SERVICE BULLETIN

APPLICABILITY: 2014MY XV Crosstrek Hybrid Models (HEV)

NUMBER: 07-98-15

SUBJECT: Relay Freezing Causing DTCs P1C30 and U0110

1. Drive Motor Control Module (DMCM)
2. DMCM Mounting Bracket
3. Relay Holder
4. DMCM Power Relay
5. Cooling Fan / Drive Motor Inverter Power Supply Relay

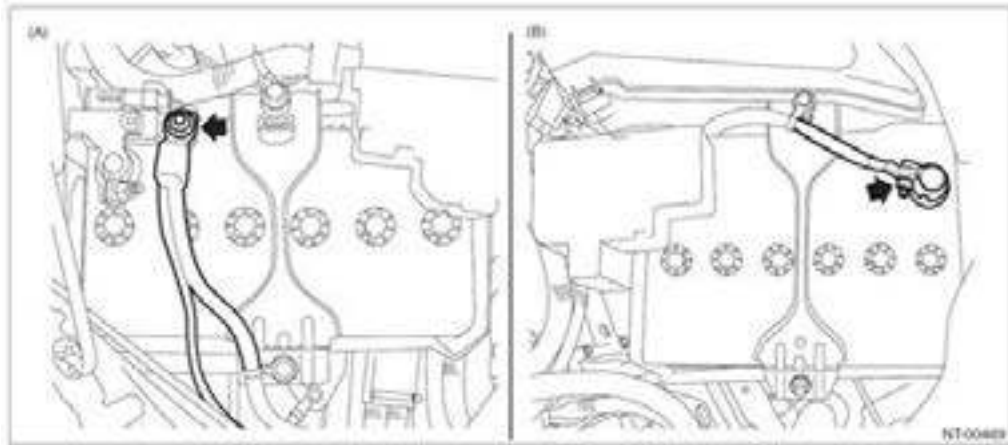
This bulletin announces a change to the power supply relay used for the Drive Motor Control Module (DMCM) and the cooling fan / drive motor inverter. In specific cold climate (below freezing) conditions, if there is a small amount of condensation inside the relay, it can in rare cases freeze and cause the relay to remain open which in some cases, sets DTCs P1C30 and / or U0110.

NOTE: The new p.n. 25230AA190 replaces the original p.n. 85201AG041 **for these 2 relay applications only**. The original p.n. 85201AG041 relay is used elsewhere in the vehicle and remains the correct part to use for those other applications as specified in the Parts Catalog.

The part number for the new relay is **25230AA190**.

- If DTC P1C30 and / or U0110 are found stored in memory and the outside temperatures are (or were recently) below freezing, replace both of the power supply relays (4 and 5) as shown in the illustration above.
- Record the customer's radio station presets (and navigation favorites where applicable).
- When either of the power supply relays is replaced, both the auxiliary and the engine start batteries must be disconnected, **auxiliary battery first**. Remove the 12mm nut from the restart battery sensor stud and remove the cable along with the ground terminal from the Auxilliary battery.

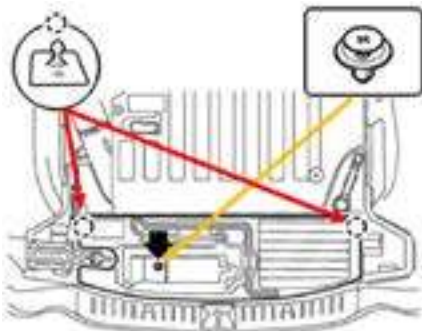
IMPORTANT: DO NOT remove the sensor assembly from the restart battery terminal.

12v Engine Restart Battery (A)

12v Auxiliary Battery (B)
